RE: LFPCN41226

Subject : LFPCN41226- Commercial TVS Datasheet Characterization

PCN Report

Prepared By : Changjun Tang, Production Engineer, Littelfuse Wuxi
 Date : July 10, 2015
 Device : All Commercial TVS product (except AK1, AK3, AK6, AK10)

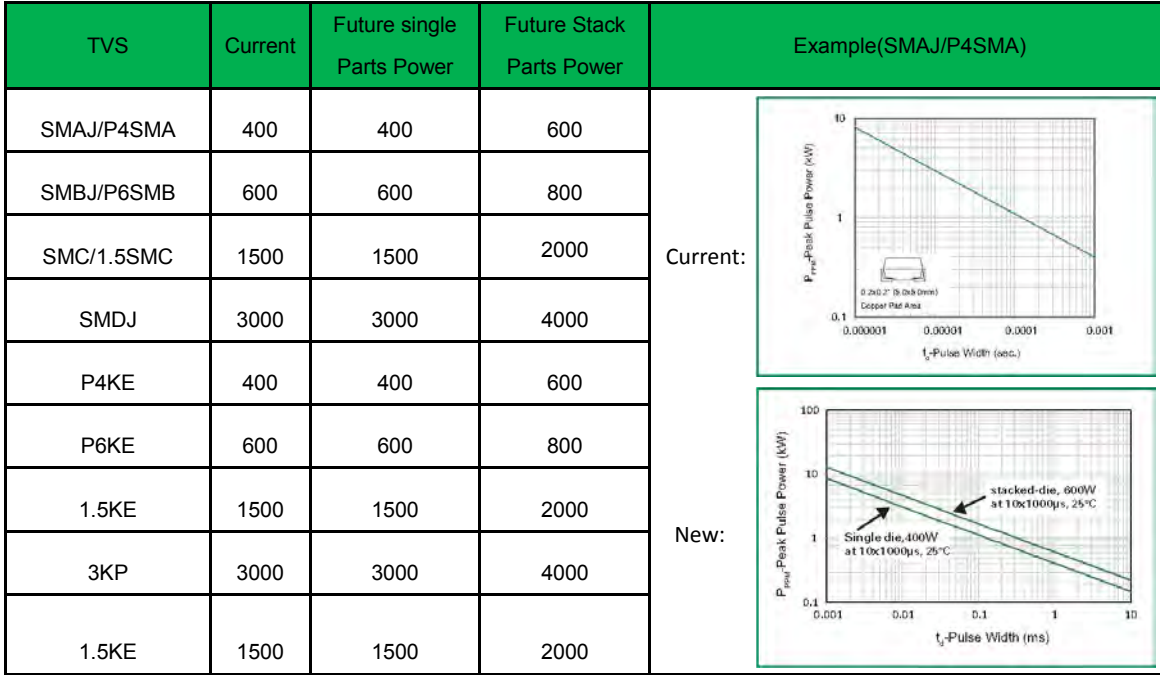
E: Update SMAJ/P4SMA series note “VF<3.5V for devices of VBR ≤ 200V and VF<6.5V for devices of VBR ≥ 201V ” to “VF < 3.5V for single dice parts and VF< 5V for stacked dice parts”
 Update the others series note “VF<3.5V for devices of VBR ≤ 200V and VF<5V for devices of VBR ≥ 201V ” to “VF < 3.5V for single dice parts and VF< 5V for stacked dice parts”

➤ Figure - Peak Pulse Power Rating Curve

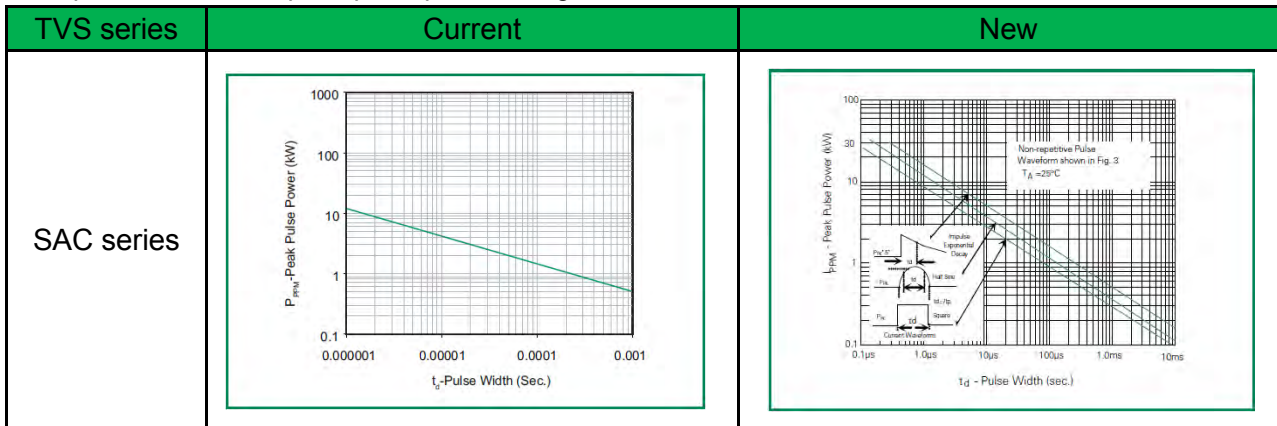
5.1 Add one curve to specify stack-die parts pulse power.

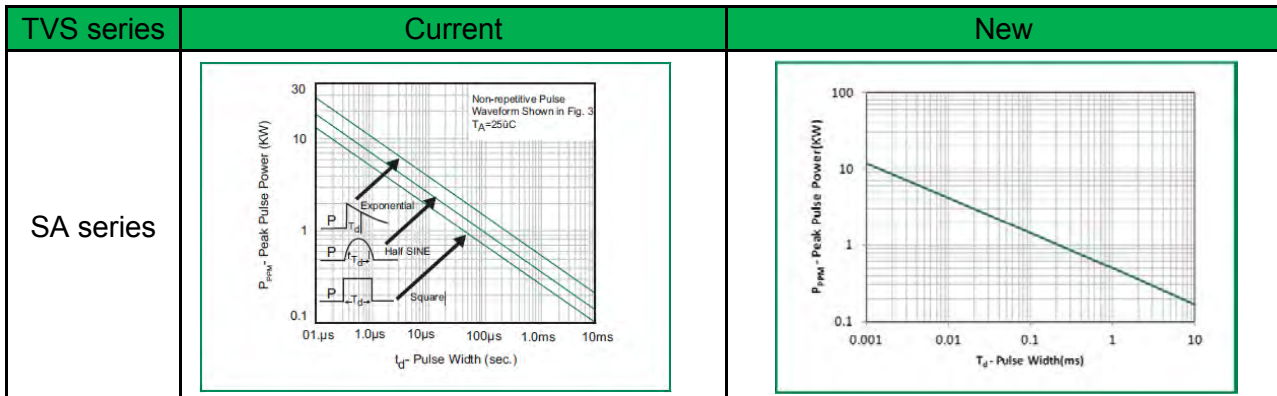
5.2 Update SAC series peak pulse power rating curve

➤ **Figure - Pulse Derating Curve**

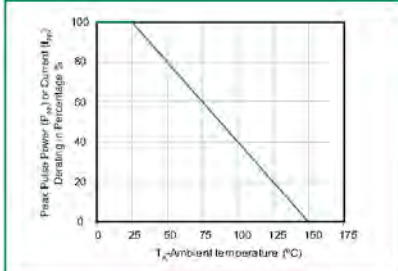
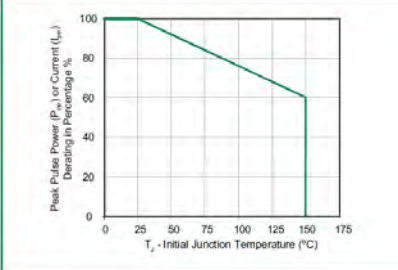
5.4 Update the derating curve.

Pulse Derating Curve			
TVS	Current Power Rating@Tjmax	New Power Rating@Tjmax	Example(SMAJ/P4SMA)
SMAJ/P4SMA	0%	60%	<p>Current:</p>  <p>New:</p> 
SMA6J/SMA6L	0%	40%	
SACB	0%	60%	
SMBJ/P6SMB	0%	60%	
1KSMB	0%	60%	
SMCJ/1.5SMC	0%	60%	
SMDJ	0%	50%	
3.0SMC	0%	50%	
4.0SMDJ	0%	50%	
5.0SMDJ	0%	50%	
P4KE	0%	50%	
SA	0%	50%	
SAC	0%	60%	
P6KE	0%	50%	
1.5KE	0%	50%	
LCE	0%	60%	
3KP	0%	50%	
5KP	0%	50%	
15KP	0%	50%	
20KP	0%	50%	
30KP	0%	50%

➤ **Figure - Typical Junction Capacitance**

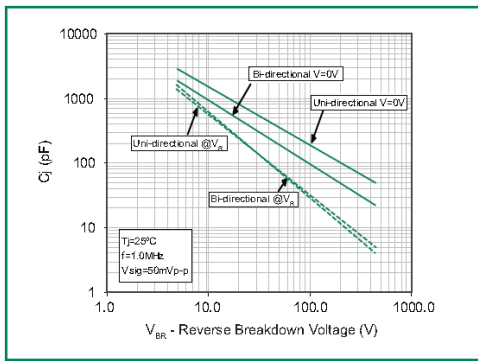
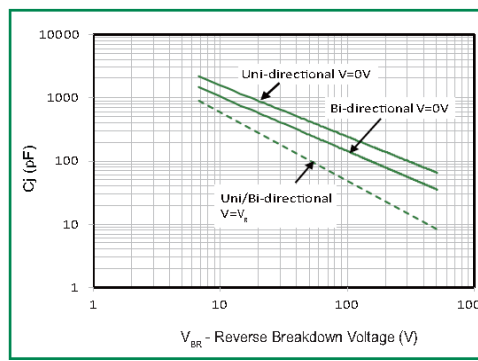
5.5 Update capacitance curve

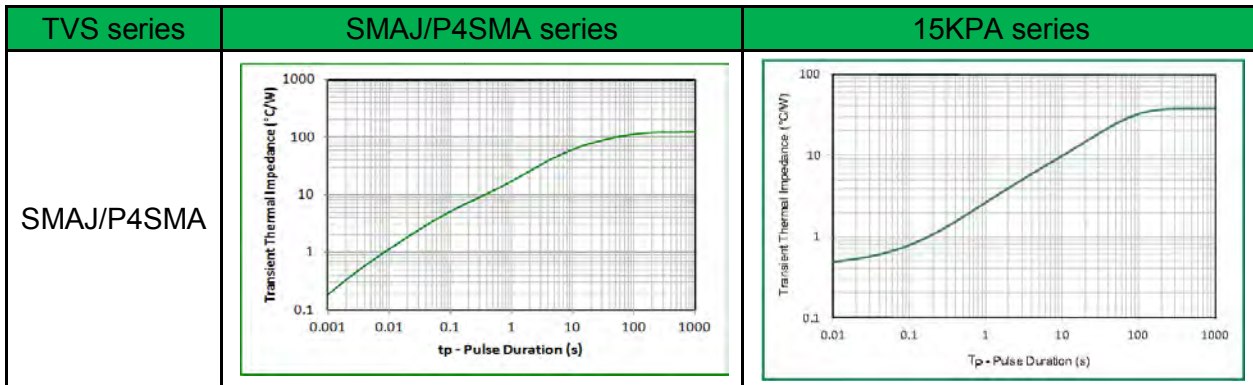
5.7 Add new figure - Typical Transient Thermal Impedance

➤ Figure - Maximum Non-Repetitive Forward Surge Current Uni-Directional Only

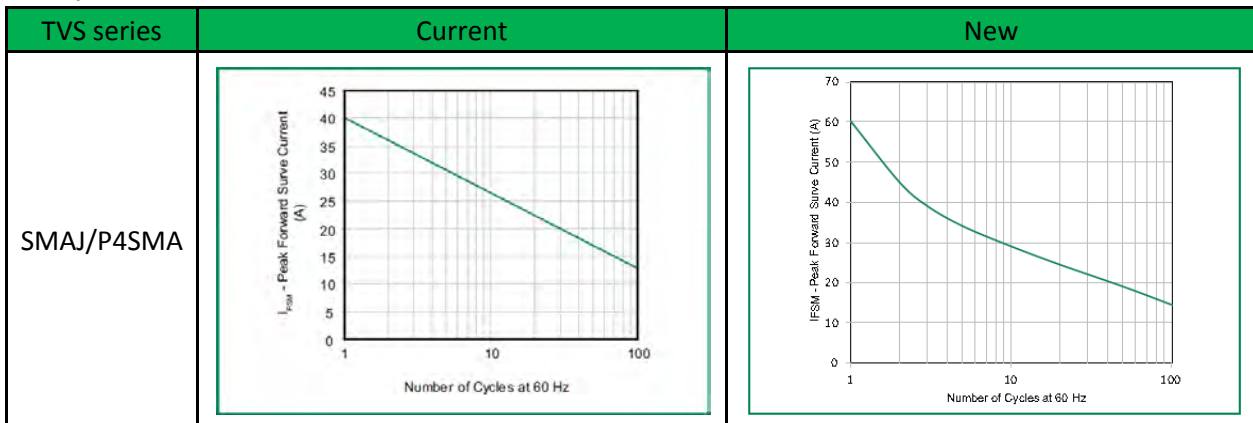
5.8 Update maximum forward surge current (uni-directional only)

➤ **Figure - Peak forward voltage drop versus peak forward current (typical values)**

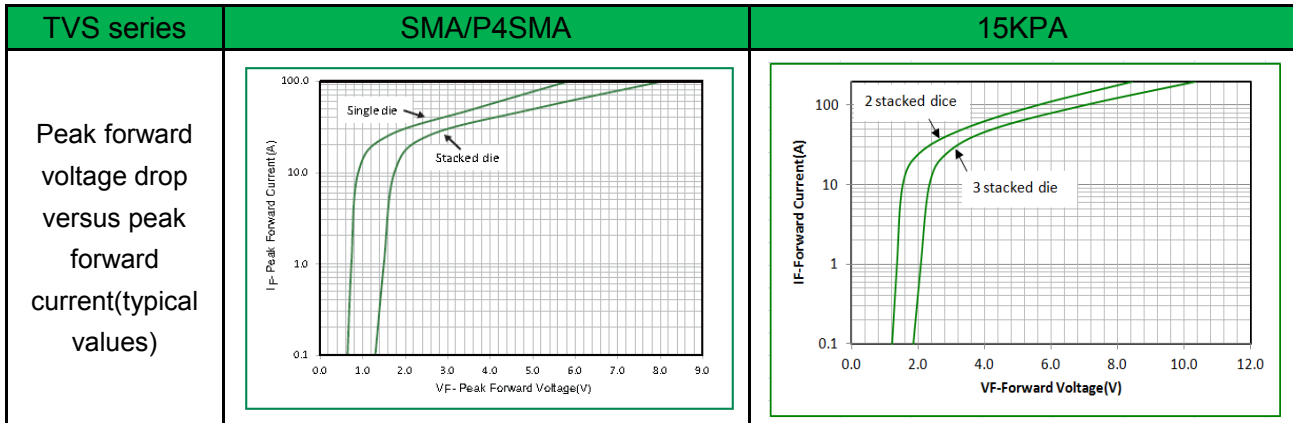
5.9 Add new figure (only apply to uni-directional TVS)
